Re: Former Olympic Service Station
1436 Grant Avenue
San Lorenzo, California
ACEHD Case No. RO0000373, GeoTacker No. T0600102256

May 3, 2011
Project No. 2115-1436-01

Re: **Interim Remedial Action Plan Addendum 2**
Former Olympic Station
1436 Grant Avenue
San Lorenzo, California
ACEHD Case No. RO0000373, GeoTracker No. T0600102256

FIGURE
1
 PROJECT NO.
 2115-1436-01

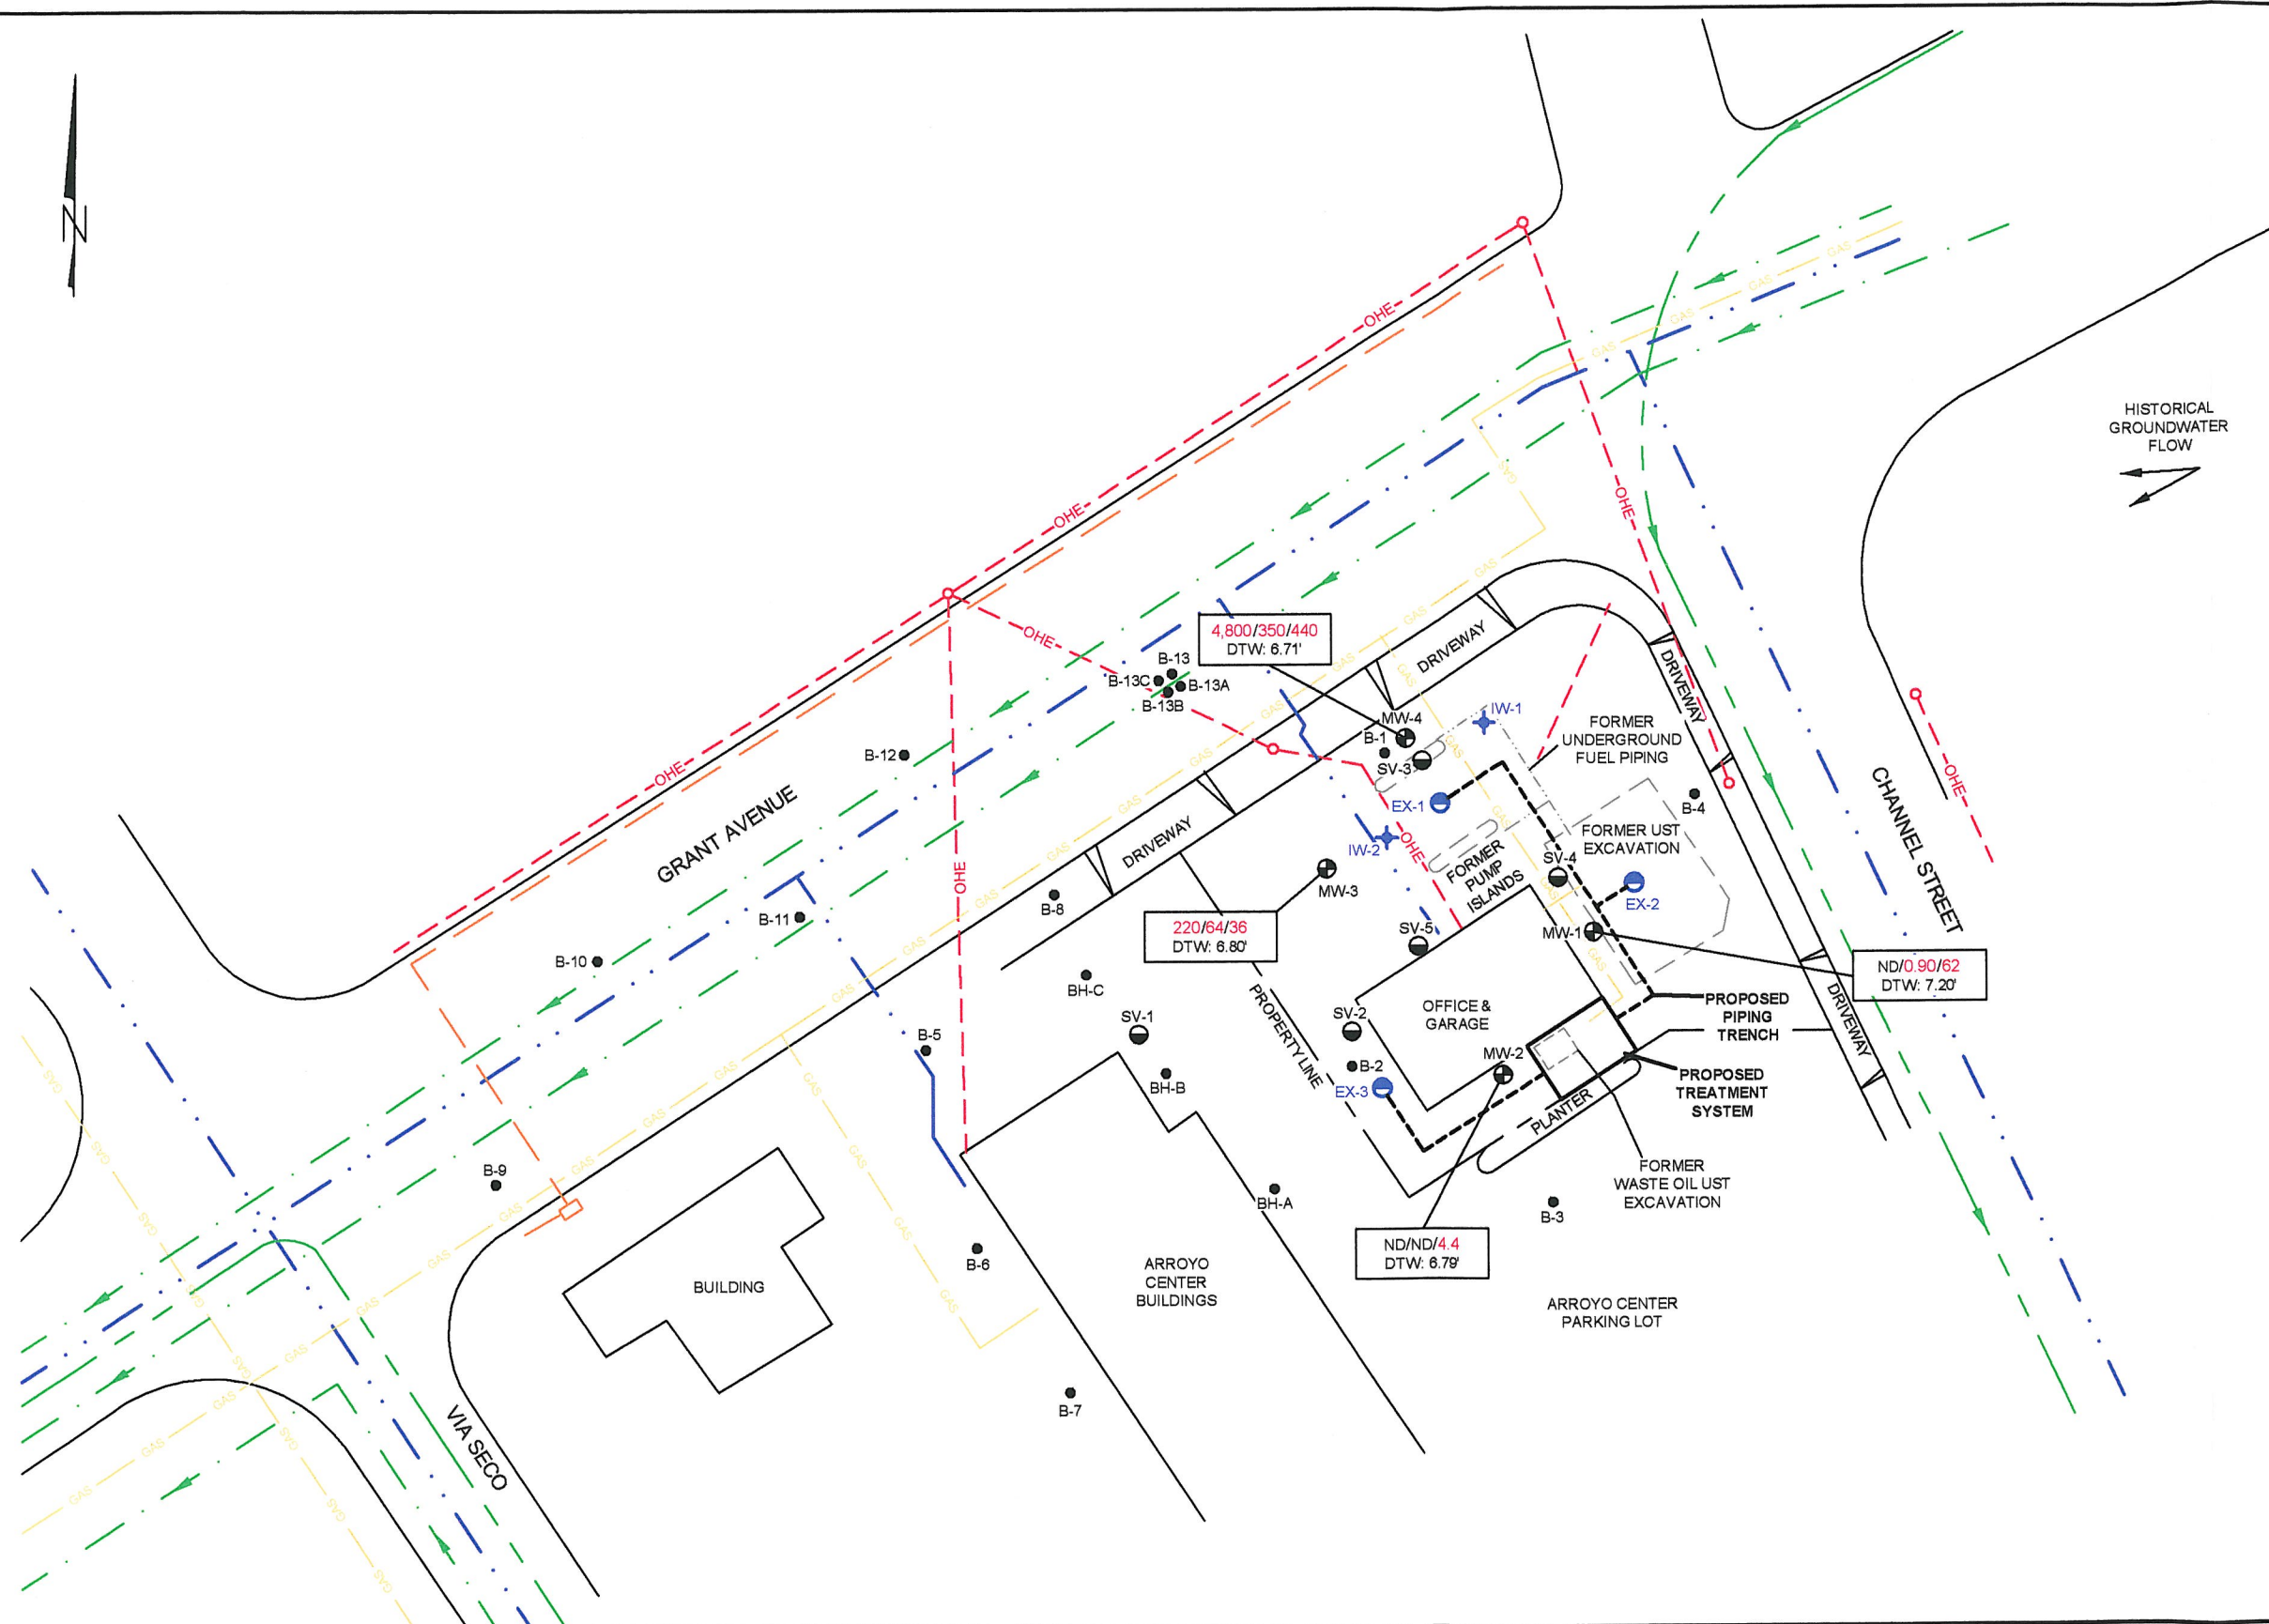
As discussed in the telephone conversation and outlined in this Addendum 2, Stratus now proposes to utilize the licensed well installation contractor who will be at the site to install the ozone injection wells (as proposed in the Addendum) to install one additional soil vapor sampling point (SV-5). This soil vapor sampling point will be installed to evaluate if the water line that runs west of the former dispenser islands is acting as a preferential pathway for contaminant migration. The specific scope of work to install soil vapor point SV-5 is outlined below.

Status proposes to install one permanent soil vapor monitoring point (SV-5) at the location shown of Figure 1. The specific tasks associated with installation of this soil vapor monitoring point are discussed below.
